Septic Pump test - clean only
(anytime)

SEWAGE DISPOSAL SYSTEM

HOWARD COUNTY HEALTH DEPARTMENT

RE: Kneeland Property
Sand Mound Design Plan
Brighton Dam Road
Tax Map 34 Parcel 299

MOUND LAYOUT
CENTRAL MANIFOLD DISTRIBUTION NETWORK
N.T.S.

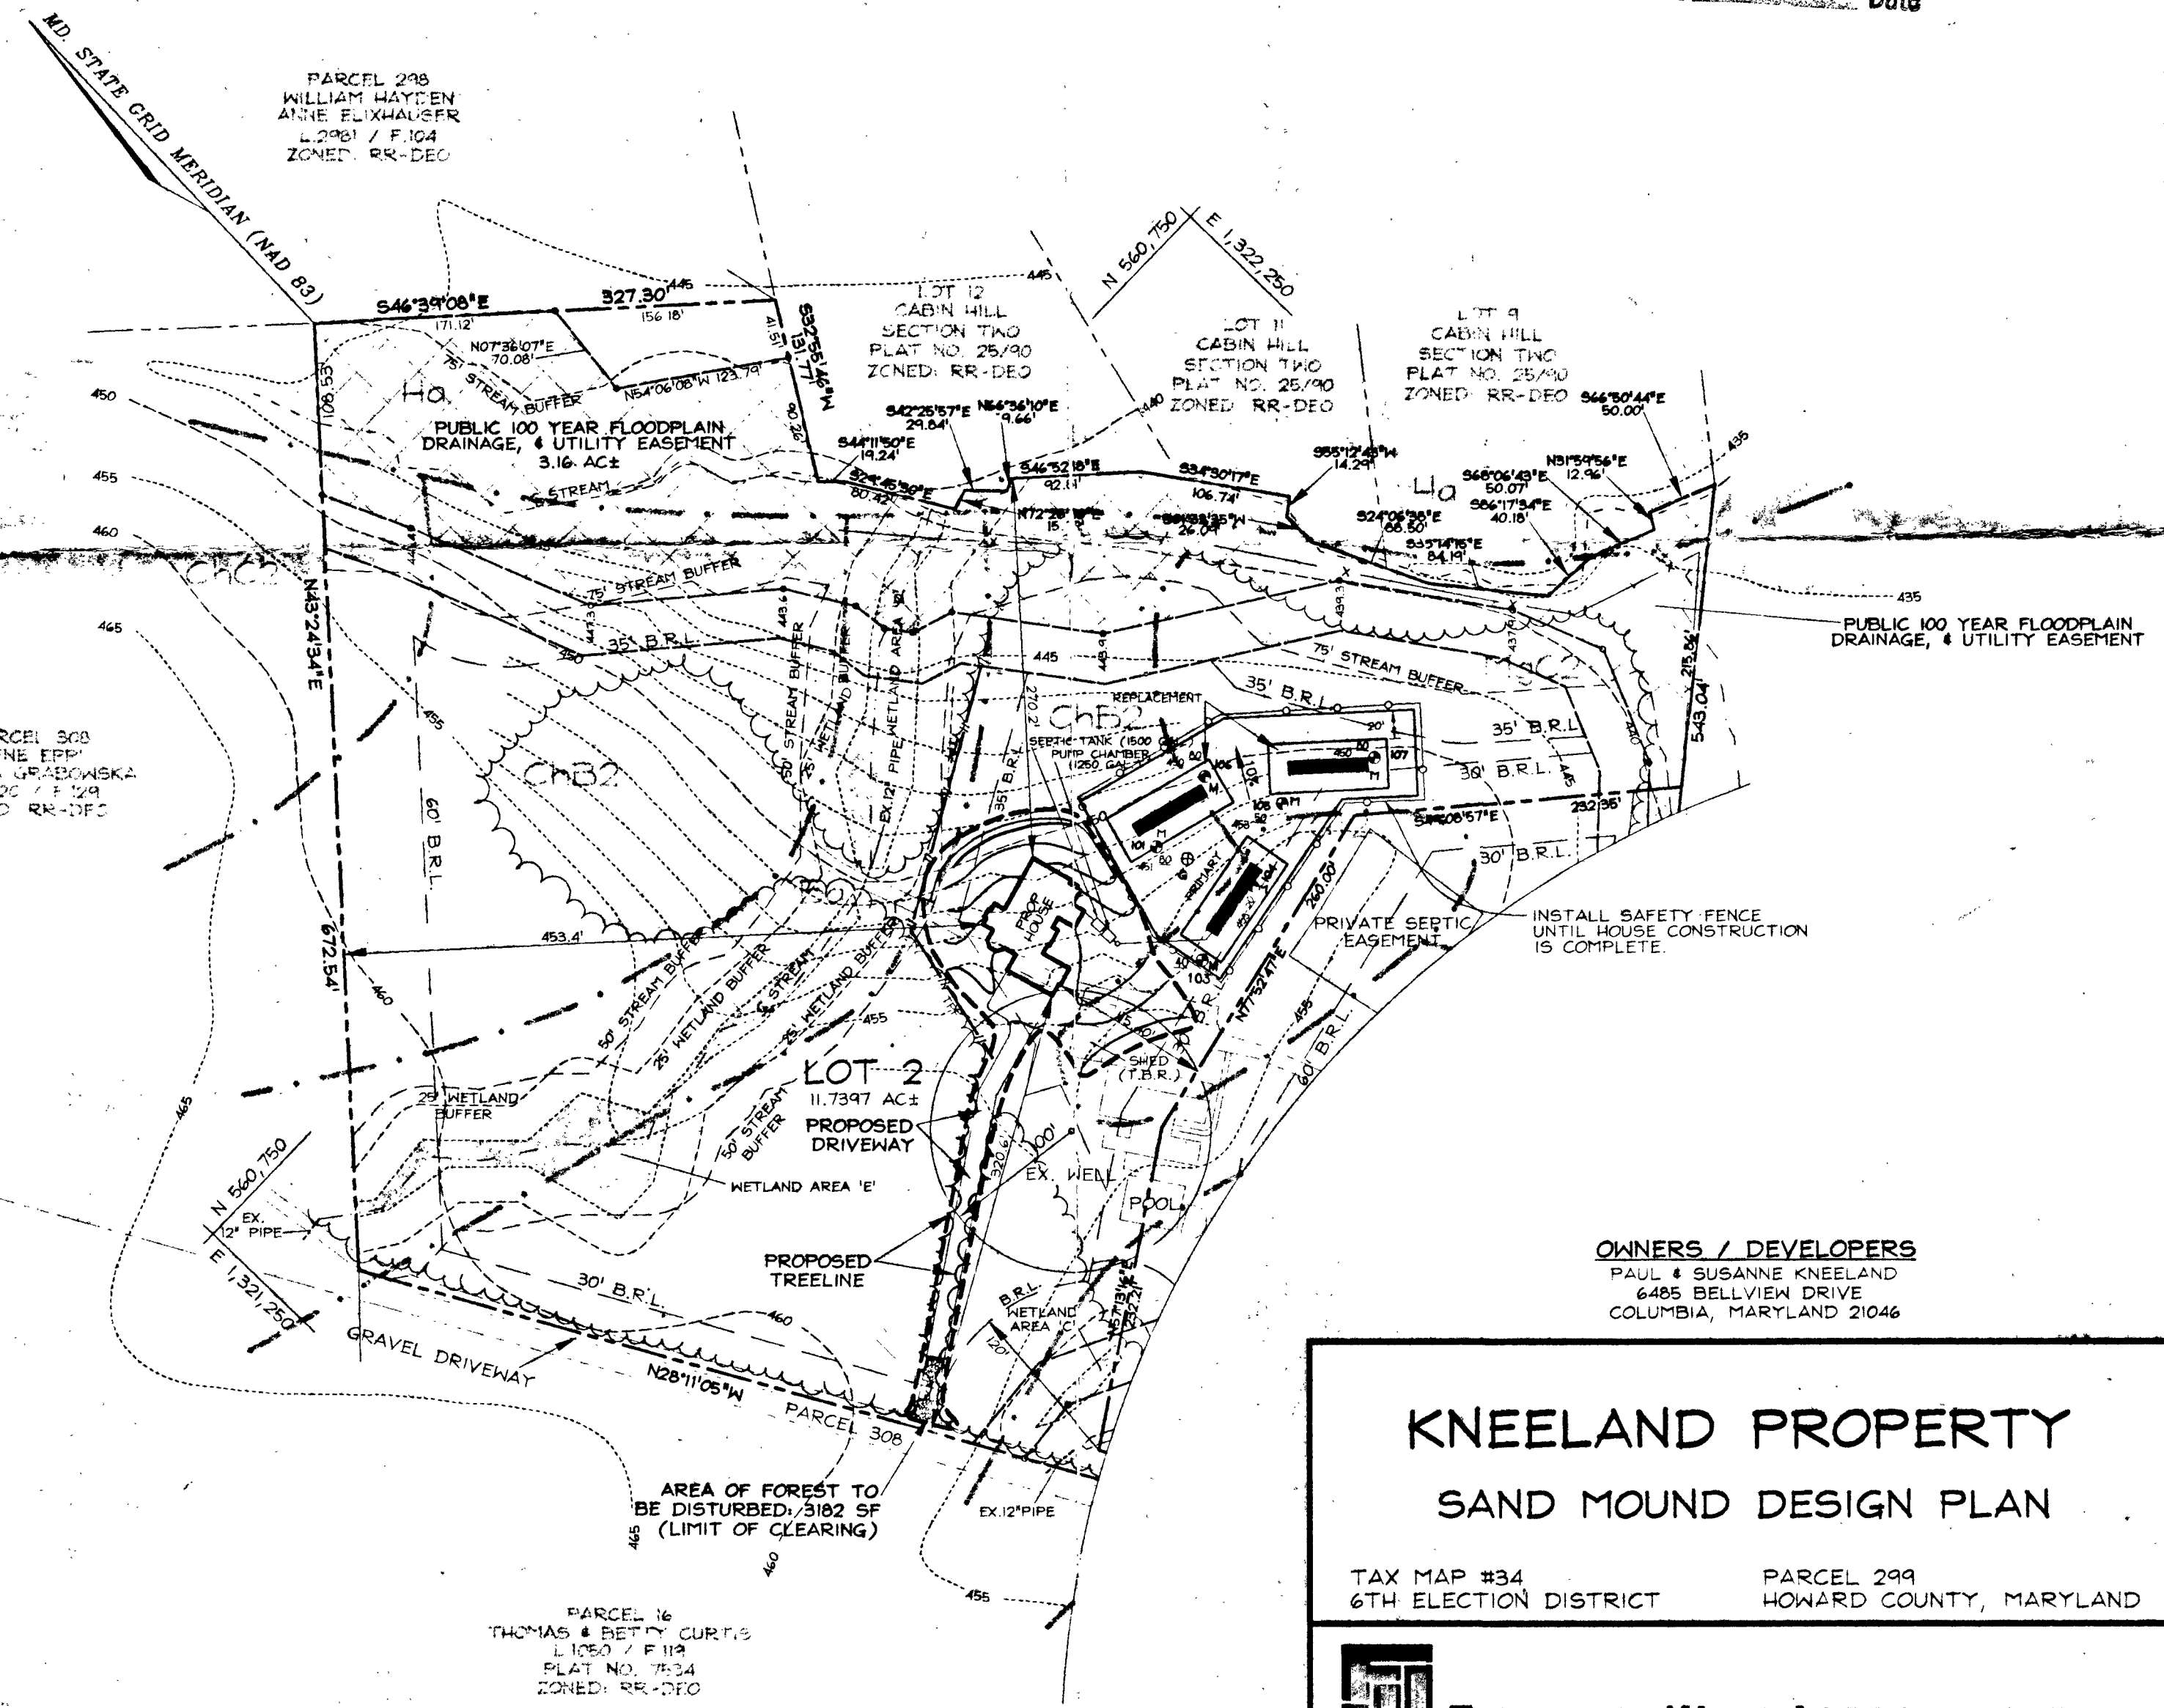
- 4) In Mound Layout Detail show the total sand mound length.
